Planning & Zoning Commission Hearing: October 17, 2024

## Tapestry Project Development Plan w/ Addition of a Permitted Use #PDP240001

### Summary of Request

*'Craftsman' and 'Farmhouse' building designs each with two color schemes*

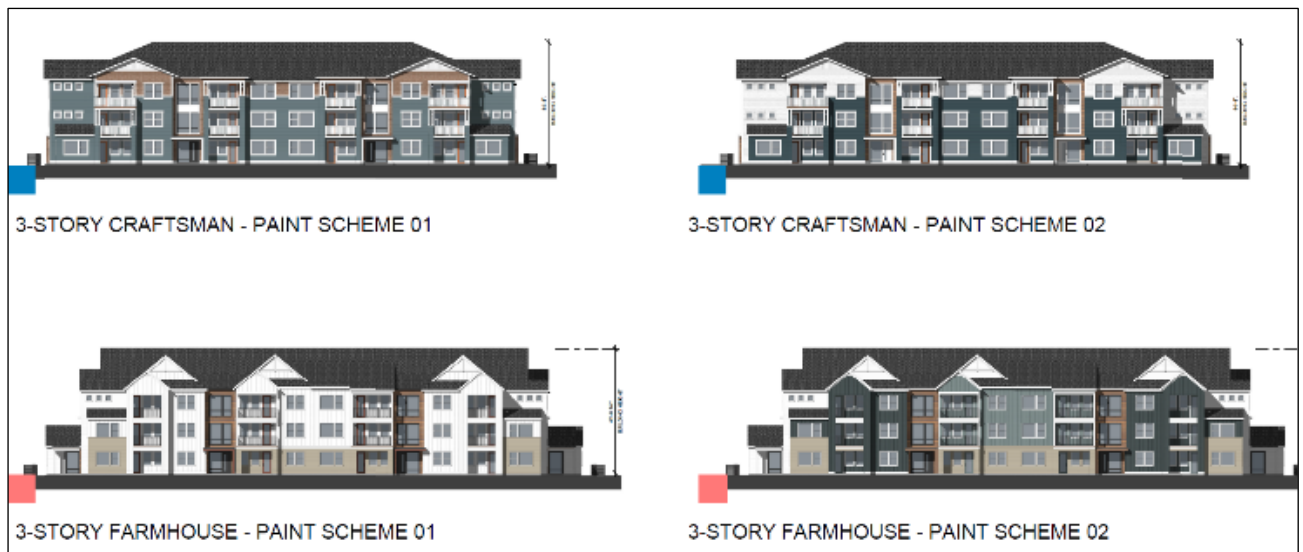
This standard would require 3 different building designs among the 7 buildings. The modification is needed because the plan has just 2 building designs.

- Variation is accomplished with the two different elevations/footprints, each with two different color schemes for a total of four.
- No street frontage has a duplicate building face fronting it.
- The plan alleviates the defined problem of affordable housing. To design and build another different building would add substantial cost and would not significantly improve the varied frontages.

*Plan diagram showing placement of the two different designs*

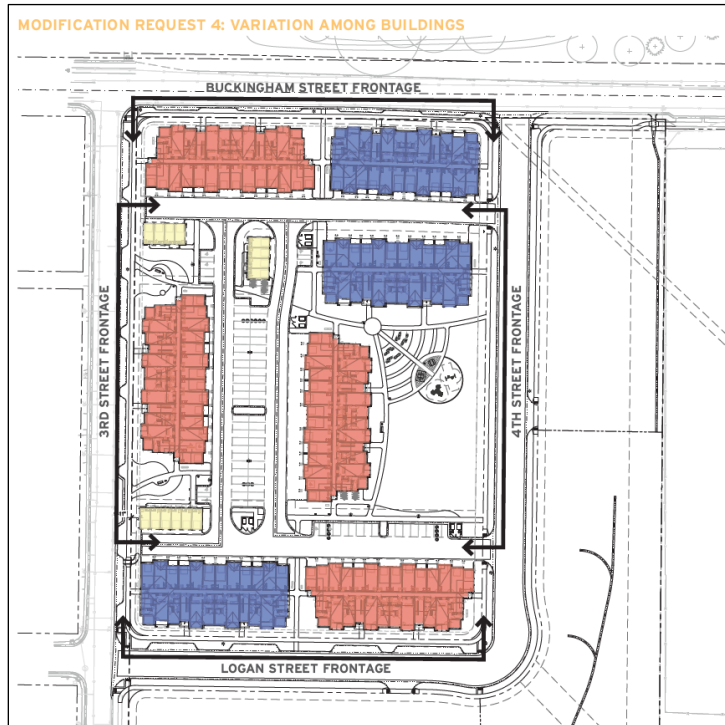
Staff finds that the modification of this standard would not be detrimental to the public good and that the request satisfies criterion (2) in subsection 2.8.2(H) – “defined community need.”

**Detriment to the public good.** Staff’s finding is based on the following considerations:

- The overall plan provides significant variation in the placement of the two building designs along the streets, with no two of the same design placed next to each other due to varying orientation together with the different designs and color schemes.
